SERVICE BULLETIN

Bulletin No: JC-13-22

Product Type: STEINER

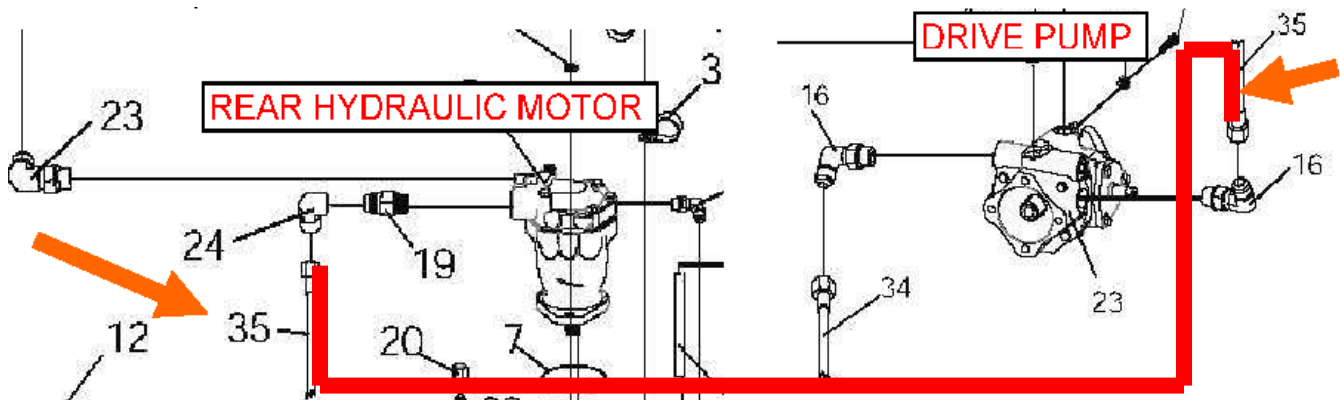
- A. Leaking drive hose
- B. Loose drive shaft = Loss of hydraulic pressures
- C. Pedal dampener working loose

- A. Hose will not hold up to all conditions in which a Steiner tractor may be used
- B. Drive shaft assembly bolts and set screws are not tight enough
- C. Dampener has potential to slide off the spacer

1. Remove hose 4166843-02 and replace it with hose 4169240-01. Tie something on to the hose and pull it through the tractor as you remove the old hose. Then use that to help pull and route the new hose into the tractor.
2. It should be easier to do this repair when you have the radiator out for drive shaft repair.

1. Drain and remove the radiator.
2. Release the belt tension going to hydraulic pump.
3. Remove the coupler set screws, retain for reuse. Remove the drive shaft assembly from the pump pulley and engine pulley. (Mark the shaft assembly: engine side and pump side) Engine side bolts are metric.

Drive shafts: KOHLER

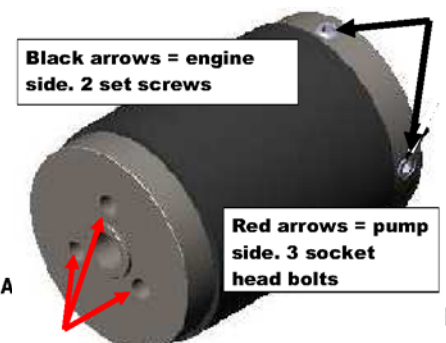
1. Remove the 4 engine mounting bolts
2. Loosen the 2 set screws in the coupler on the engine side

3. Lift and move the engine forward separating the drive shaft or pulling the coupler off the engine crankshaft.
4. Remove the coupler from the pump pulley.

6. Reassemble the drive shaft
 - Install the pump coupler onto the pump pulley. Torque the 3 bolts to 22 ft.-lbs.
 - Slide the engine into place, inserting both couplers into the rubber insert and bolt it tight.

- Slide the engine coupler until there is approximately 1/16" gap between the rubber insert and one coupler. This allows crankshaft endplay.
 - Apply removable lock-tight on the set screw threads and in the threads of the coupler on the engine side. Double set both set screws to 12 ft.-lbs.
